PLAN COMMISSION AGENDA ITEM EXECUTIVE SUMMARY				
	Project Title/Address:	First Street Phase 3 – Streetscape Plan			
ARK.	City Staff:	Russell Colby, Planning Division Manager			
ST. CHARLES	13/0/15				
APPLICATION	1	Streetscape Plan Approval			
ATTACHMENTS AND SUPPORTING DOCUMENTS:					
Staff Memo		Preliminary Streetscape Plan

**RE:** First Street Phase 3 – Streetscape Plan

**DATE:** December 4, 2015

# FIRST STREET STREETSCAPE PHASE 3 - BUILDING 1

# 2015 Phase 3 Plan

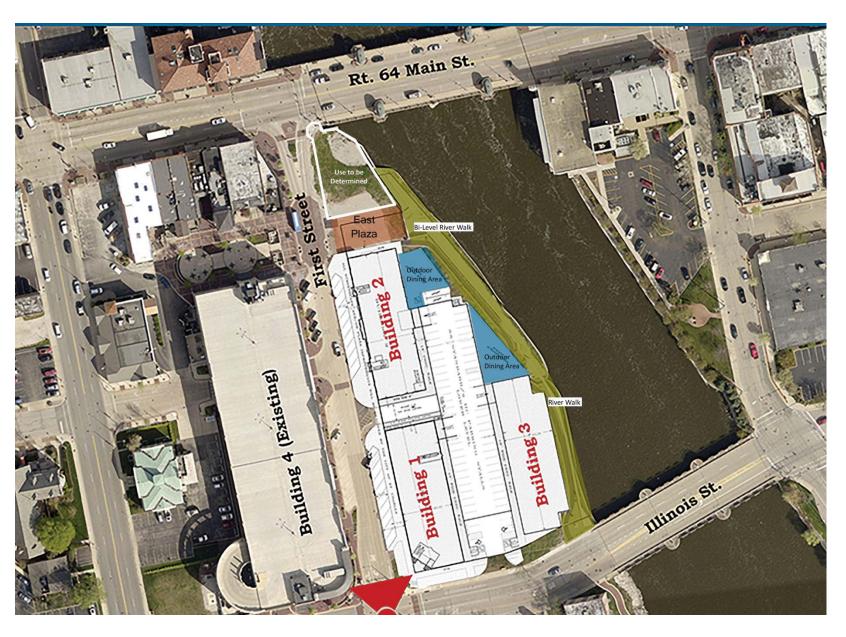
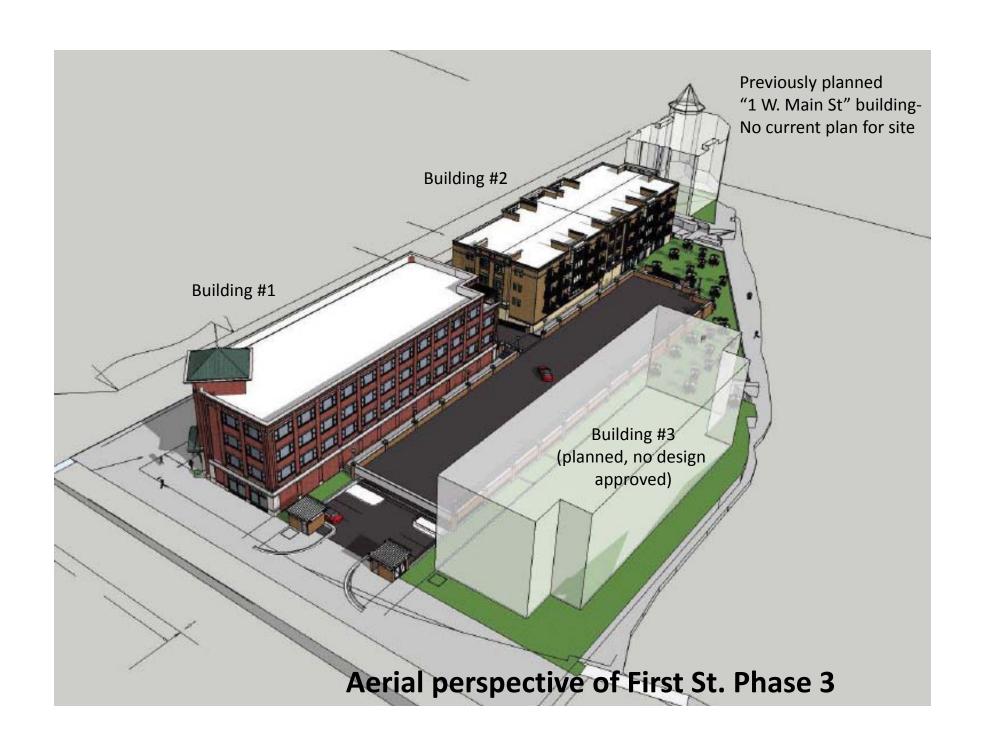
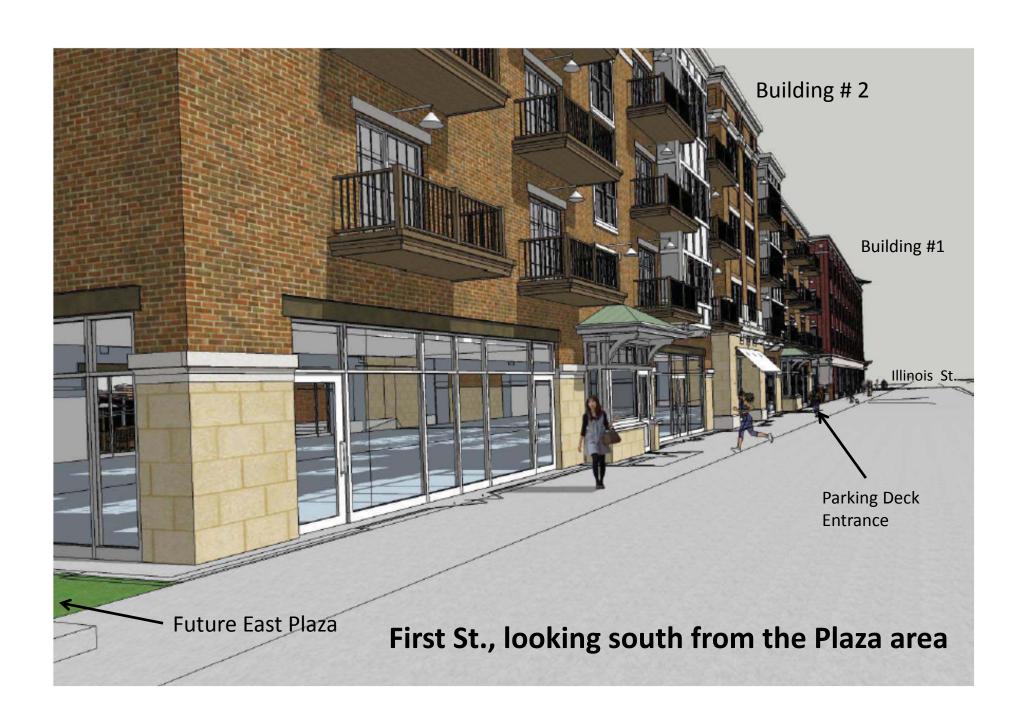
- Overall, the layout does not respond well to the buildings in certain locations.
- The design has limited functionality of the pedestrian sidewalk zone and prevented use of the sidewalk as an active space.

- Planter boxes were spaced apart in a set pattern, and as a result, some boxes were placed directly in front of storefront entrances.
- Trees within some planter boxes ended up being removed or badly pruned to improve business visibility.

- Plans did not account for balconies and upper story building projections. Specifically, at the BMO Harris building, trees have grown up into the balconies.
- Trees grow quickly and conflict with building projections, giving the street a crowded, overgrown appearance.
- The trees then require significant pruning, which leads to a misshapen tree.

• Landscape planter boxes placed within the sidewalk area can create choke points at certain locations, leaving tight spaces for pedestrians trying pass on the sidewalk.

- Including landscape planter boxes along the entire length of the sidewalk area limits the use of sidewalks by people and businesses.
- The west side of First St. has provided only limited opportunity for outdoor seating, displays, or activities.

- Too many trees can hide building architecture.
- As trees mature, they create a dark tunnel effect, which conflicts with the desired character of an open, urban street environment.

- Utilize the same design framework (theme and details/materials) as the existing First Street streetscape:
  - o Same brick materials and same design with an edge ribbon

- o Same pedestrian street lamps
  - o Same benches and garbage cans
  - o Same type of tree grates
- Streetscape is designed around all building entrances, storefront locations, and anticipated door swings (where storefronts are not recessed into the buildings).

- Maximized usable sidewalk width:
  - o Generally, keeping 10+ ft. open in front of buildings (Only narrowing down to 8 ft. along Illinois St., where there are no storefront entrances)

- Limit planter areas to building corners, where they will not conflict with the usable sidewalk area.
  - Create more substantial planting areas in less usable locations, instead of many smaller planter boxes.

- Space out trees, don't plant in sidewalk areas around balconies
  - o No trees will be placed within the sidewalk immediately adjacent to Building #2, which will have balconies along the entire First St. façade.

- o Shade trees have been placed in larger planter beds at the ends of the buildings where they will have room to grow larger.
  - o Columnar trees have been placed at other locations, but spaced so as not to block direct views of storefronts or signs.
